APPLICATION TO THE ZONING BOARD OF ADJUSTMENT

Application of Paul and Sharon Schifano
44 Lennox Avenue
Block 37, Lot 20
Zone R-5

Memorandum – Denial Memo

Applicant: Paul and Sharon Schifano
 Property Address: 44 Lennox Avenue, Rumson, New Jersey 07760
 Block 37, Lot 20, Zone: R-5

DATE: 2/19/25
DRAWN BY: MB
SHEET NO.: Z-1

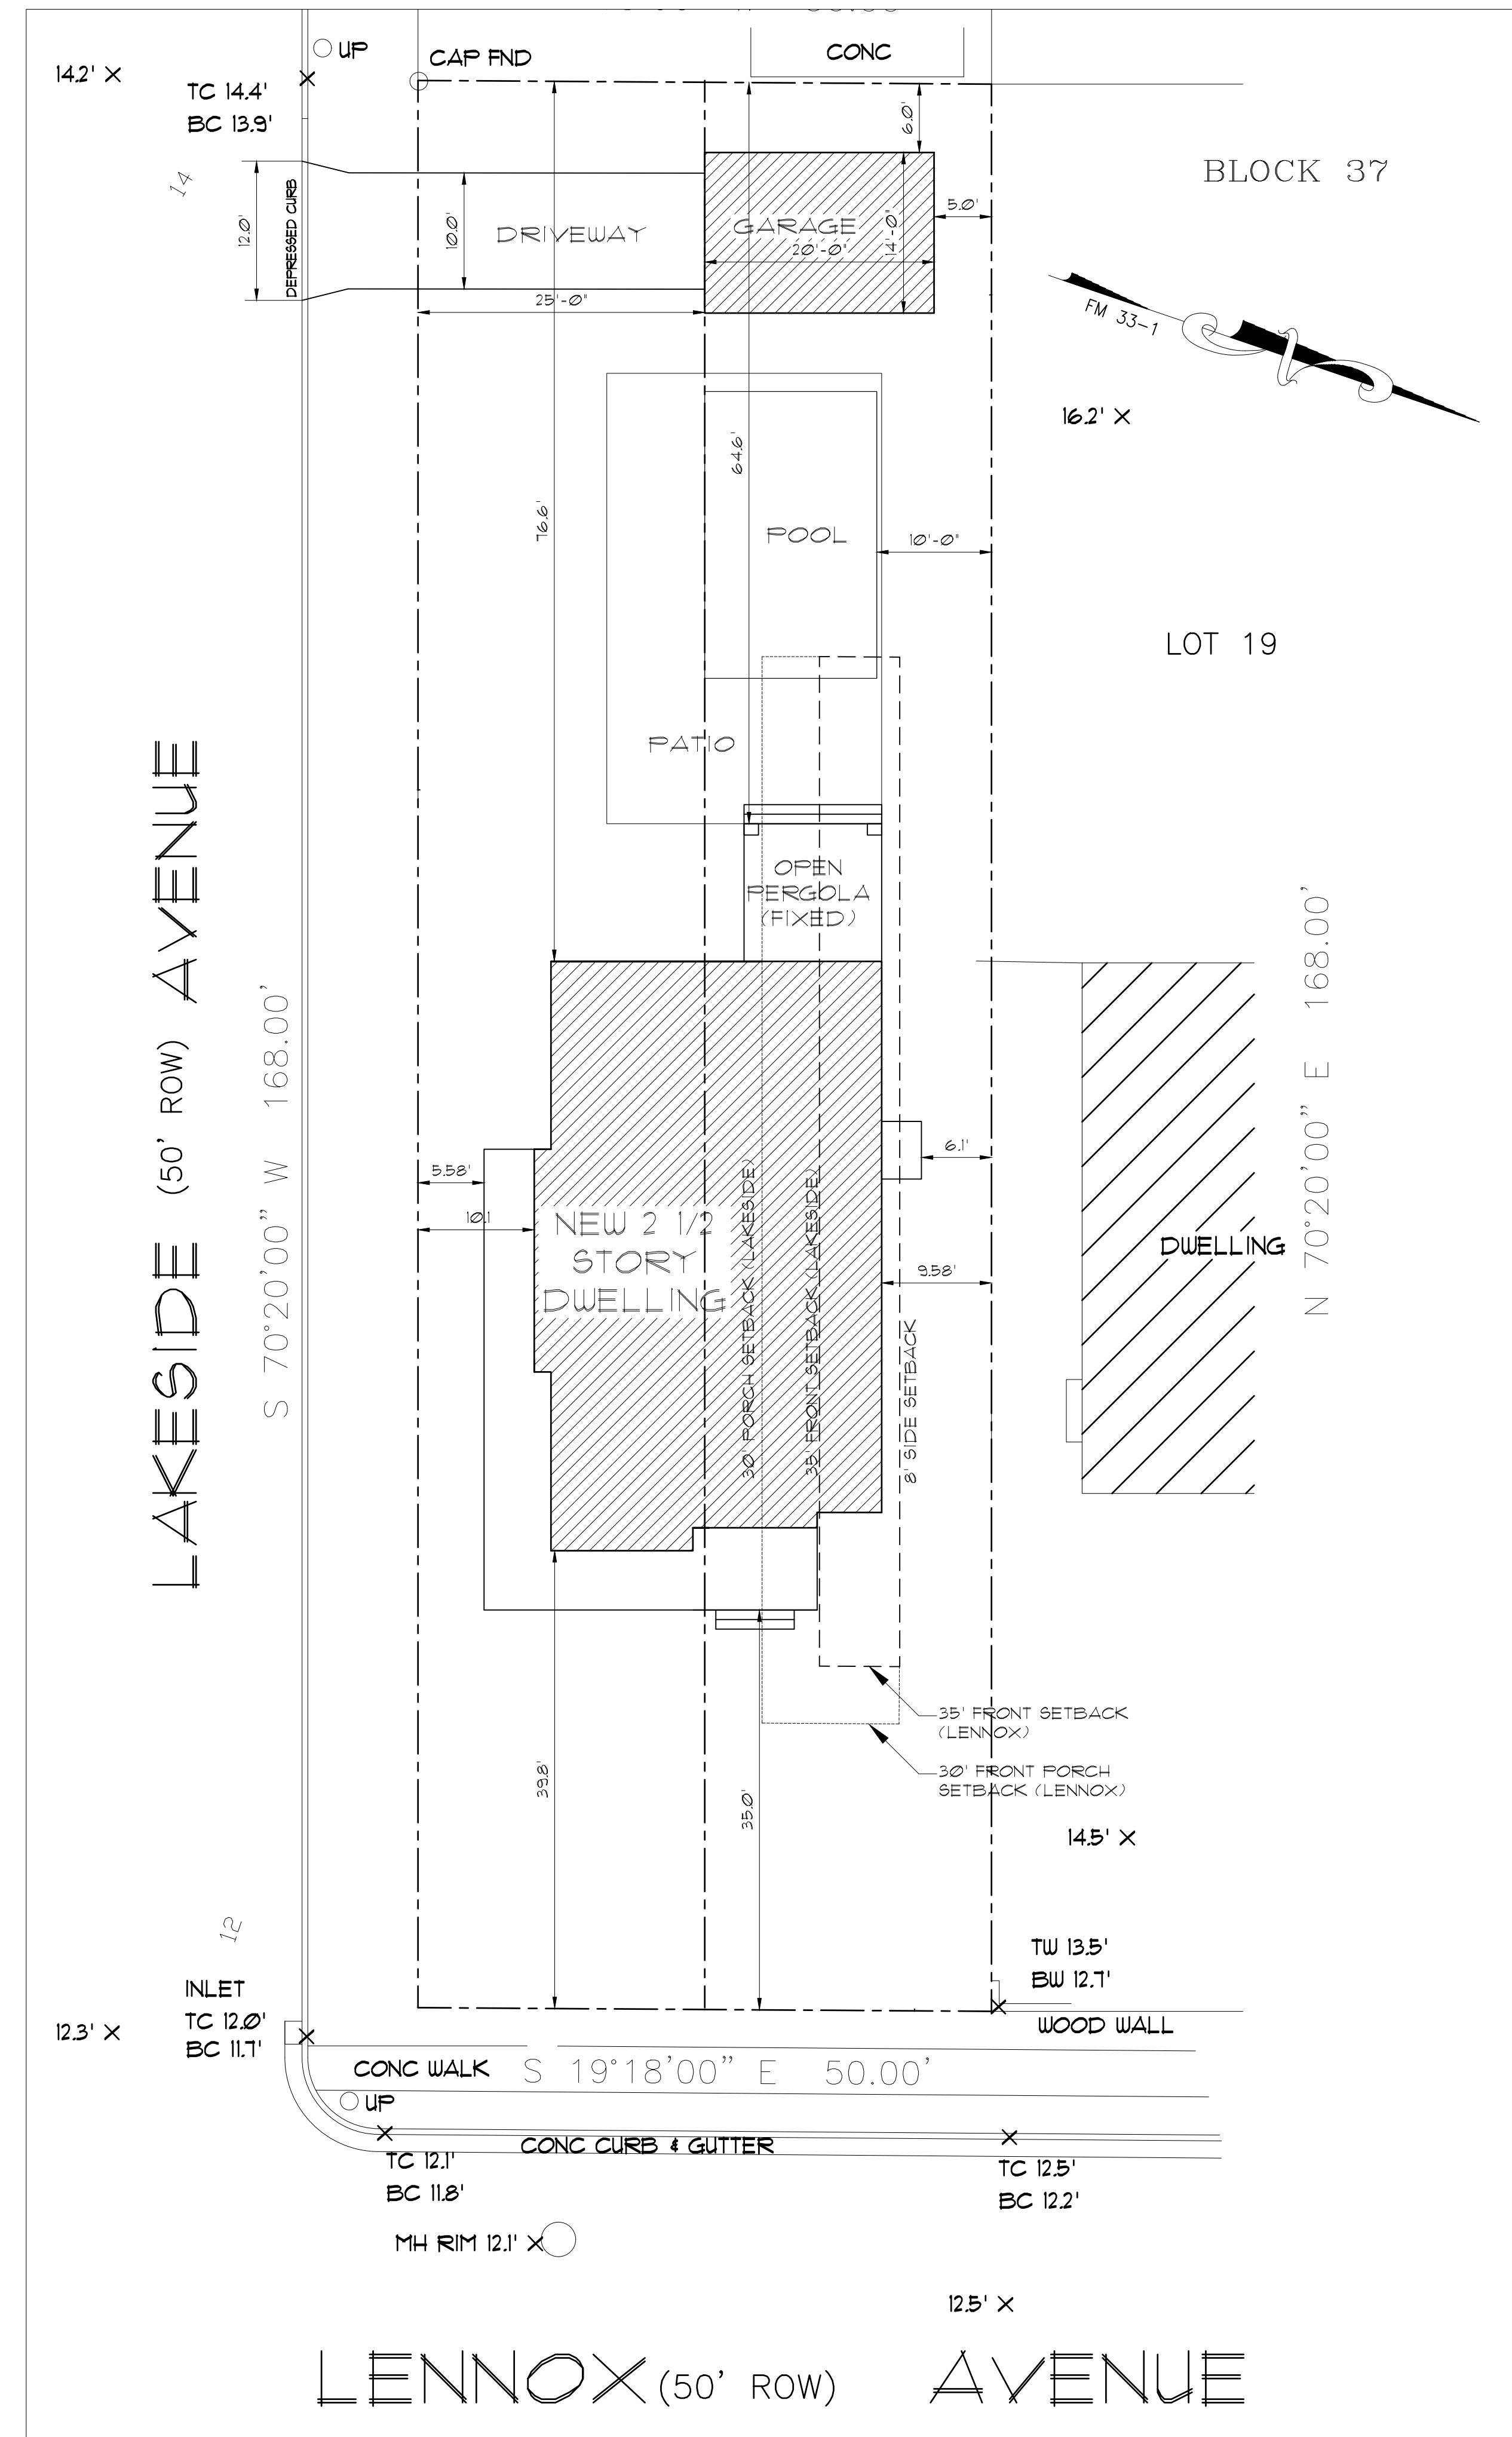
- ✓ • The site plan on sheet Z-1 shows a proposed 1-car detached garage. Architectural plans/specifications are required for approval.
- ✓ • The proposed plan is lacking driveway details and is therefore deficient in demonstrating compliance with the driveway limitations of Ordinance 22-7.26.
- • The proposed plan is deficient of the required off street parking required by Ordinance 22-9.2b for amount of spaces required and approved parking areas.
- The Zoning Chart requires the following modifications:
 - ✓○ Zoning Data shall show existing and proposed setbacks (per application instructions).
 - ✓○ The Interior lot shape diameter not filled in (required for any resolution).
 - ✓○ The proposed rear yard setback is to the attached pergola (22-7.8).
 - ✓○ The minimum pool setbacks are incorrect (22-7.8).
